City of Norman
ADA Self-Evaluation and Transition Plan
Building Cost Projection Summary
5/1/2018

Site Accessibility Evaluation

Municipal Complex - Building A

Accessibility Evaluation

Finding: 5

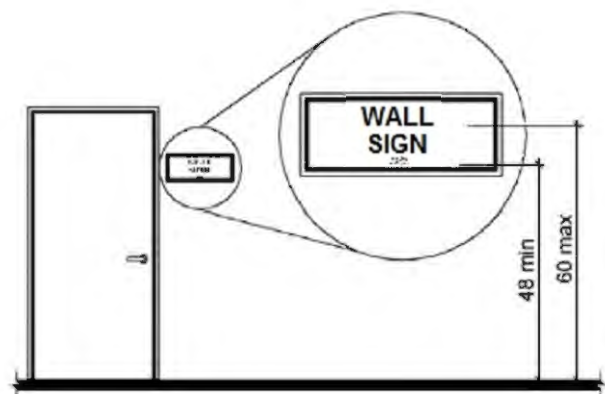
Conference rooms A-D have paper signage provided. Conference rooms C & D have 2 entrances. Conference room B currently has no signage.

2010 ADAS Section 216.2

Install compliant signage with Braille and tactile characters on the latch side of the doors.

Finding: 8

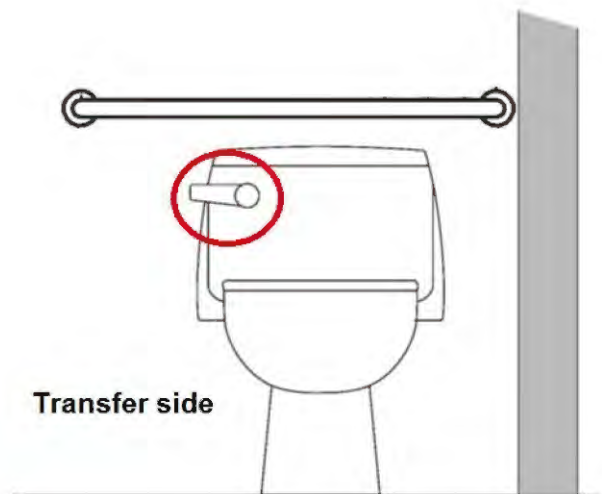
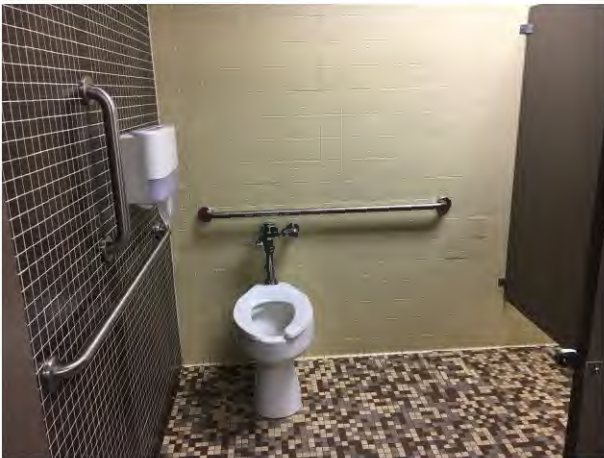
The flush handle is located on the wrong side of the water closet.

2010 ADAS Section 604.6

Modify water closet to provide flush control on opposite side of water closet.

Finding: 9

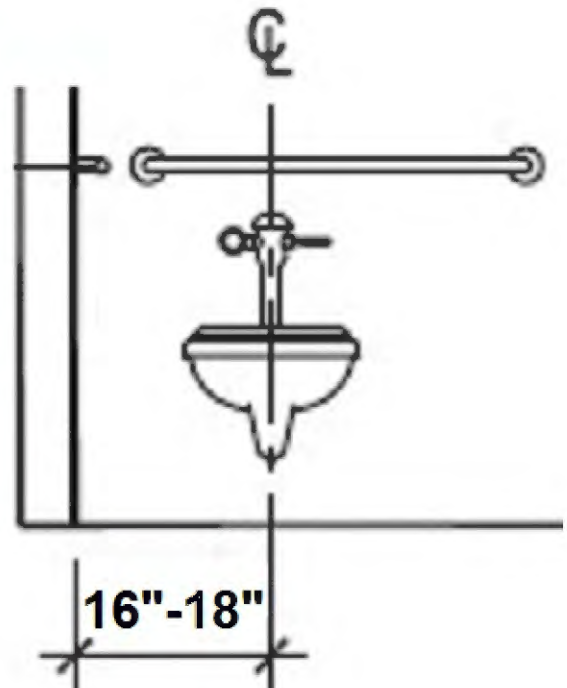
The water closet is located 19-1/2" from from the side wall or partition.

2010 ADAS Section 604.2

Relocate the water closet so the centerline is at 16"-18" from the side wall.

Finding: 10

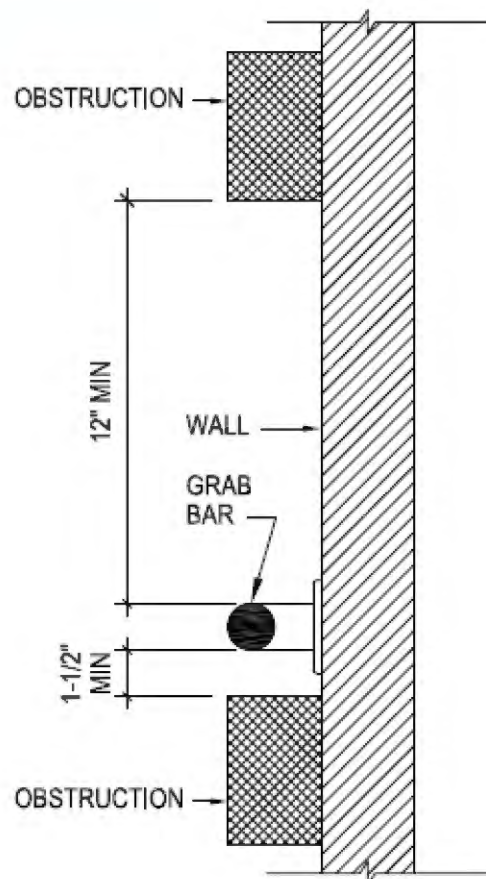
The toilet paper dispenser is mounted too close to the top of the grab bar, minimizing the gripping surface.

2010 ADAS Section 609.3

Relocate toilet paper dispenser so it is 12" from the top of the grab bar to the bottom of the dispenser.

Finding: 11

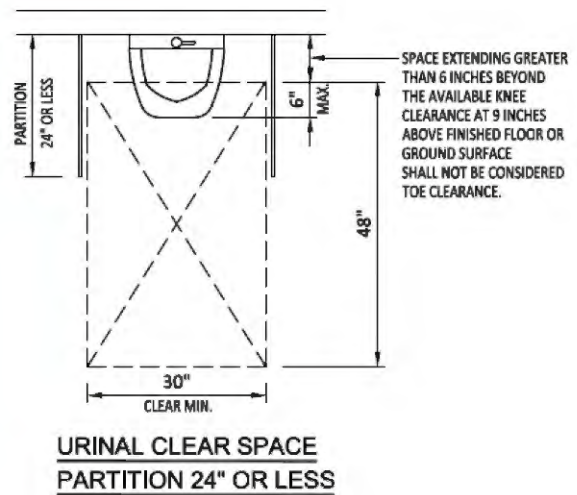
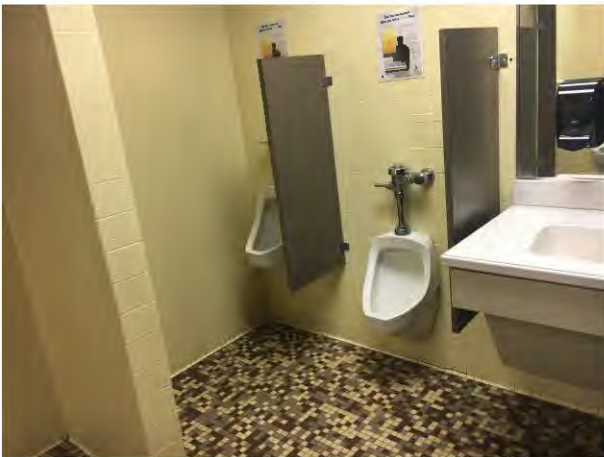
The urinal is located in an area that only allows a 29-1/2" wide clear floor space for a front approach. There is a wing wall that blocks the required clear floor space.

The surrounding elements of a urinal must provide a minimum of 30" by 48" of clear floor space for a front approach.

2010 ADAS Section 605.2

Reduce the width of the wing wall to provide the required clear floor space at the urinal.

Finding: 12

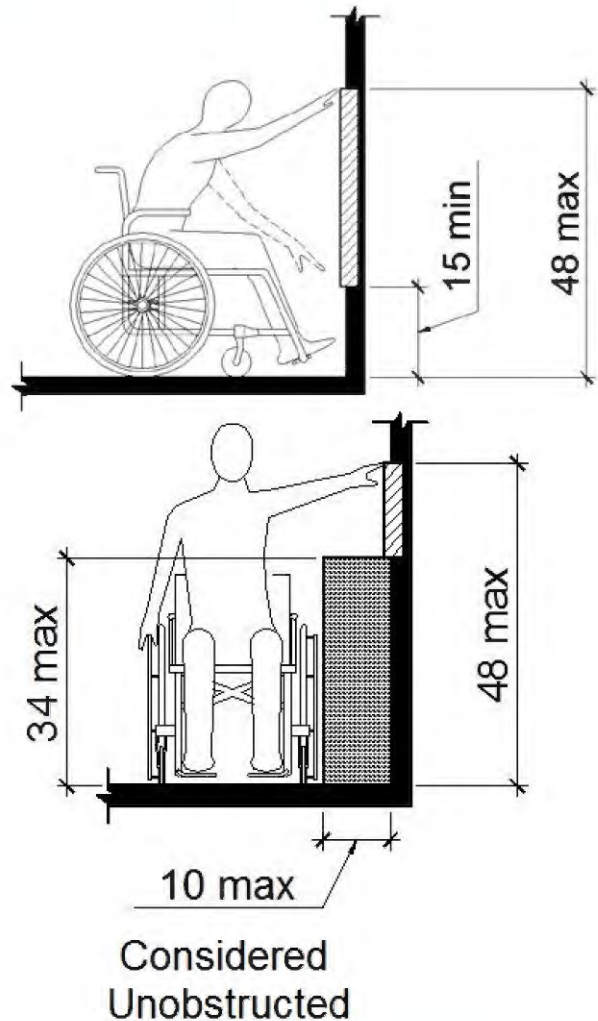
The coat hook is installed at 57-1/2" where a maximum of 48" is required.

2010 ADAS Section 308.2.1

Add a coat hook that is no higher than 4" above finished floor.

Finding: 14

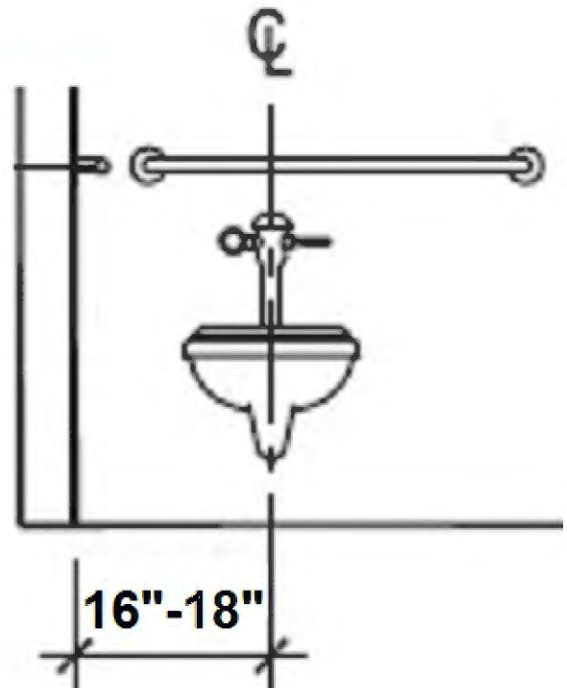
The water closet is located at 19" from the side wall to the centerline.

2010 ADAS Section 604.2

Relocate the water closet so the centerline is at 16"-18" from the side wall.

Finding: 15

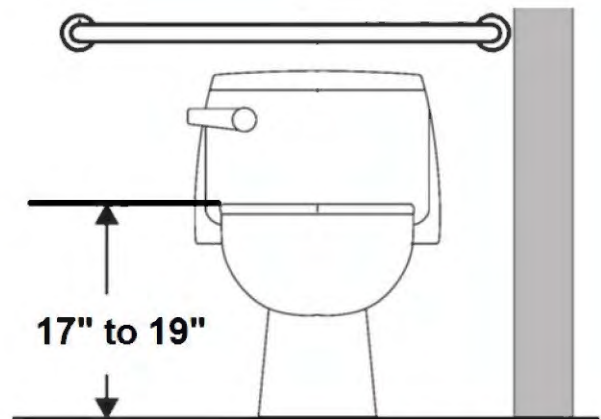
The water closet seat is 19-5/8" to the top of the seat.

2010 ADAS Section 604.4

Replace water closet seat with a shorter seat to achieve 17"-19" height.

Finding: 16

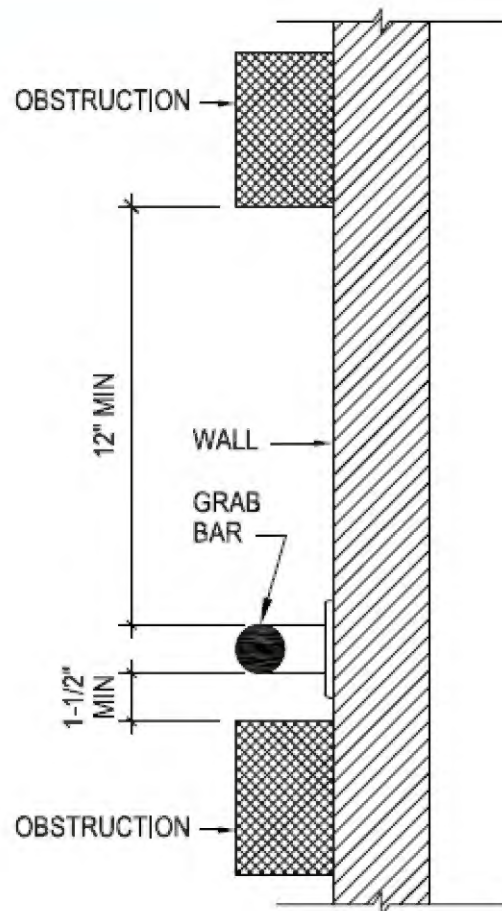
The toilet paper dispenser is mounted 9" to the top of the grab bar, minimizing the gripping surface.

2010 ADAS Section 609.3

Relocate toilet paper dispenser so it is 12" from the top of the grab bar to the bottom of the dispenser.

Finding: 17

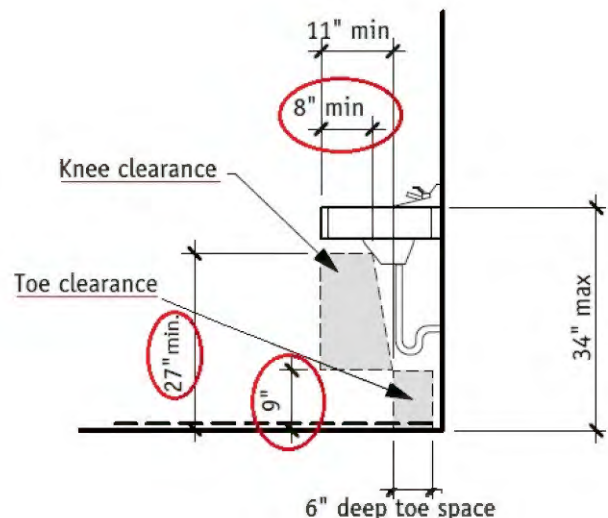
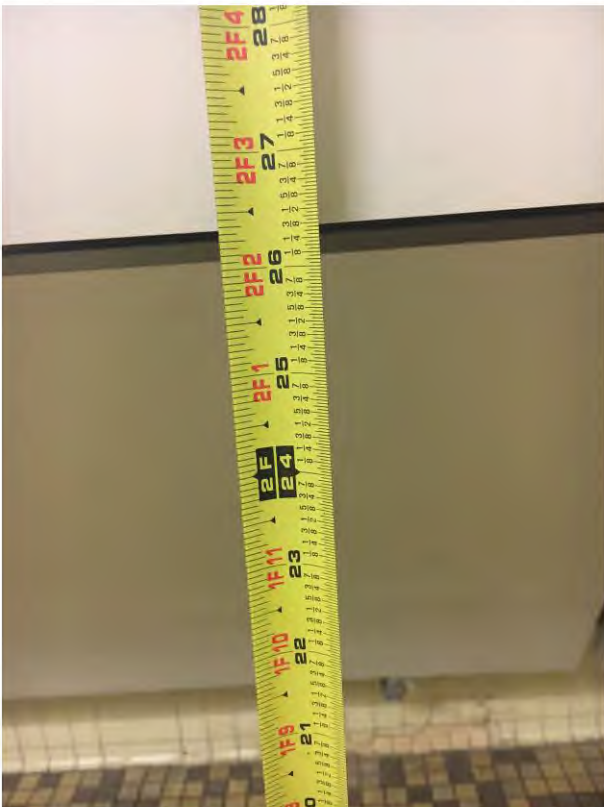
Knee clearance at the lavatory is only 26-3/8" where a minimum of 27" is required.

2010 ADAS Section 306.3.1

Modify counter to provide a 27" minimum knee clearance.

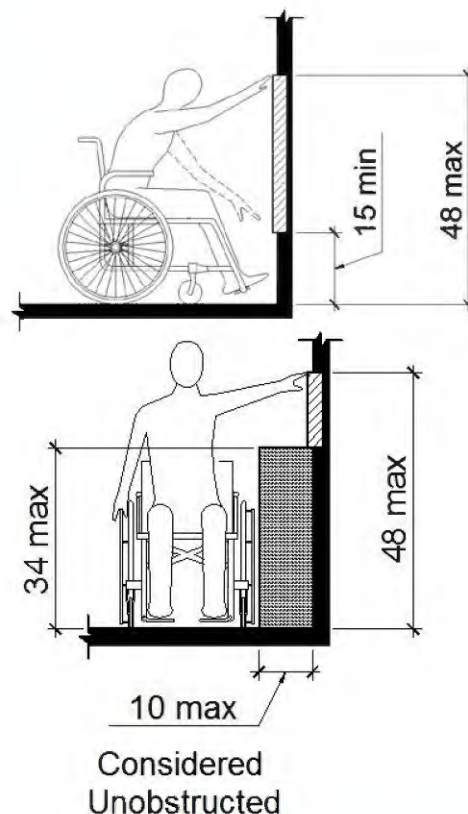
2010 ADAS Section: 308.2.1, 308.3.1

Provide a microwave where the highest operable part is at 48" above finished floor.

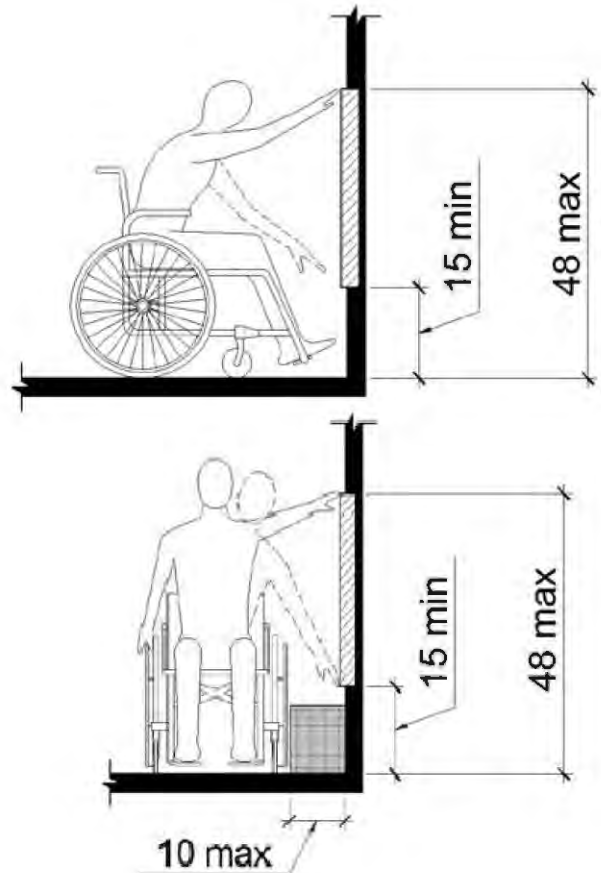
2010 ADAS Section: 308.1

**Current
Condition:**
50"

Provide a payment drop box where the payment slot is no higher than 48" above finished floor.

Finding: 27

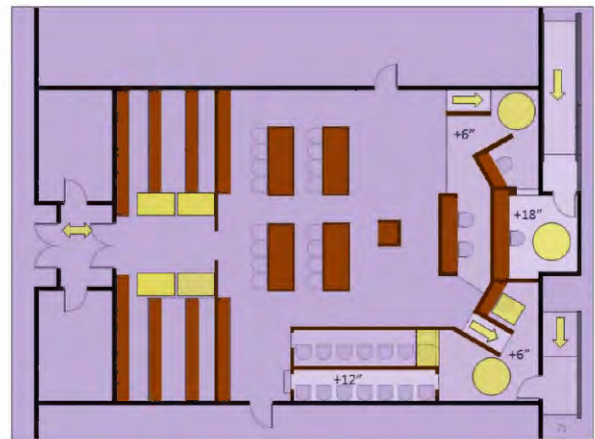
Where provided, areas that are raised or depressed and accessed by ramps or platform lifts with entry ramps shall provide unobstructed turning space complying with 304.

Provide an accessible route to the witness stand and the jury box.

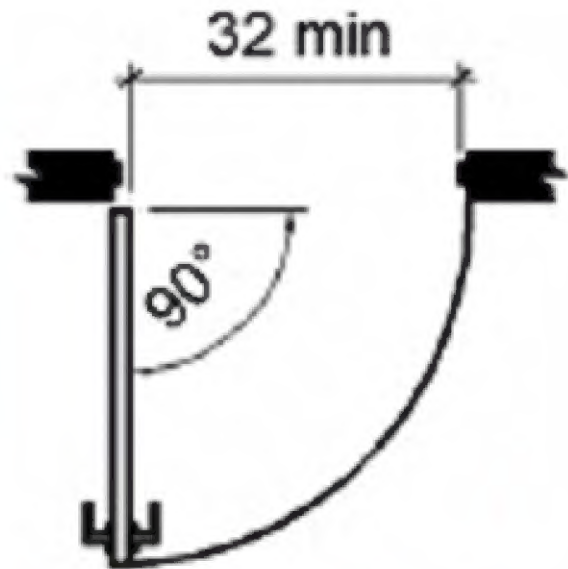
The door openings for the small offices inside the main office for Lisa Tullius provide only 31" and 29" clear width.

Door openings shall provide a clear width of 32 inches (815 mm) minimum. Clear openings of doorways with swinging doors shall be measured between the face of the door and the stop, with the door open 90 degrees. Openings more than 24 inches (610 mm) deep shall provide a clear opening of 36 inches (915 mm) minimum. There shall be no projections into the required clear opening width lower than 34 inches (865 mm) above the finish floor or ground. Projections into the clear opening width between 34 inches (865 mm) and 80 inches (2030 mm) above the finish floor or ground shall not exceed 4 inches (100 mm).

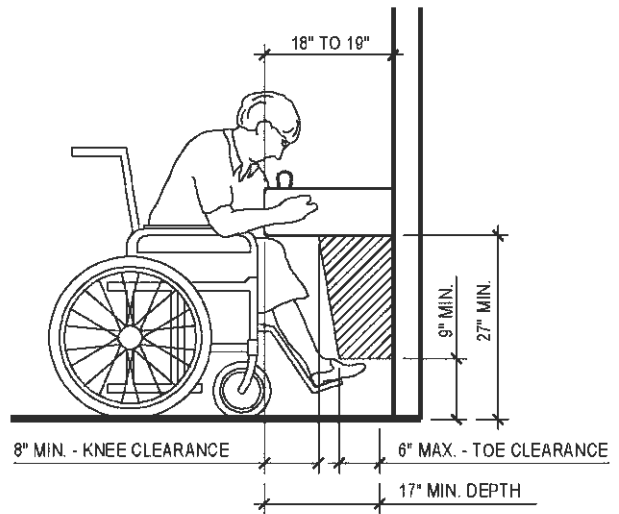
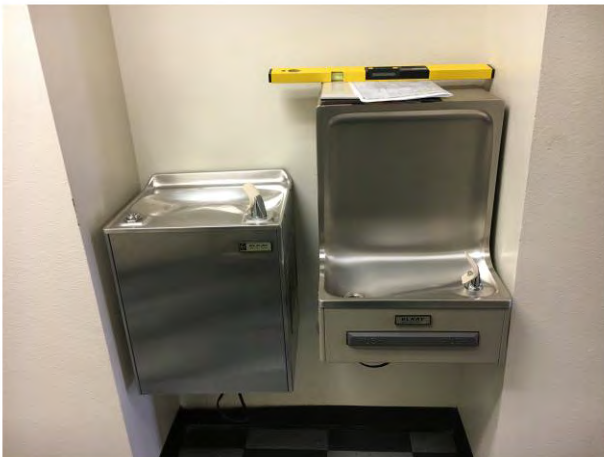
25-3/4"

Raise the low accessible drinking fountain to provide a minimum of 27" knee clearance.

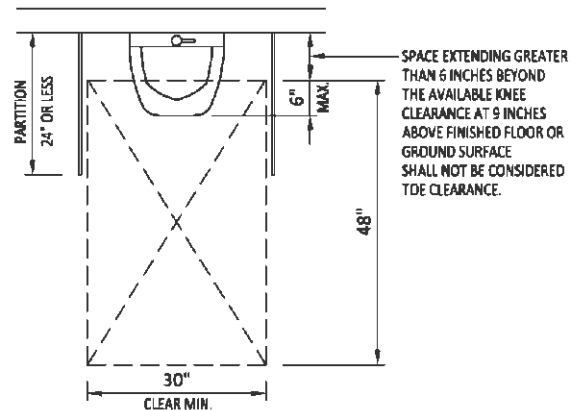
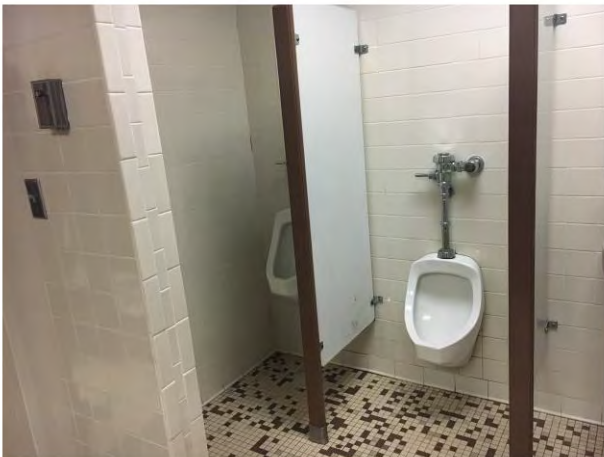
The urinal is located in an area that does not provide the required clear floor space for a front approach. Additionally, it is located in an alcove that is 24" deep and only 27" wide.

2010 ADAS Section: 605.2

Remove urinal partitions to provide the required clear floor space.
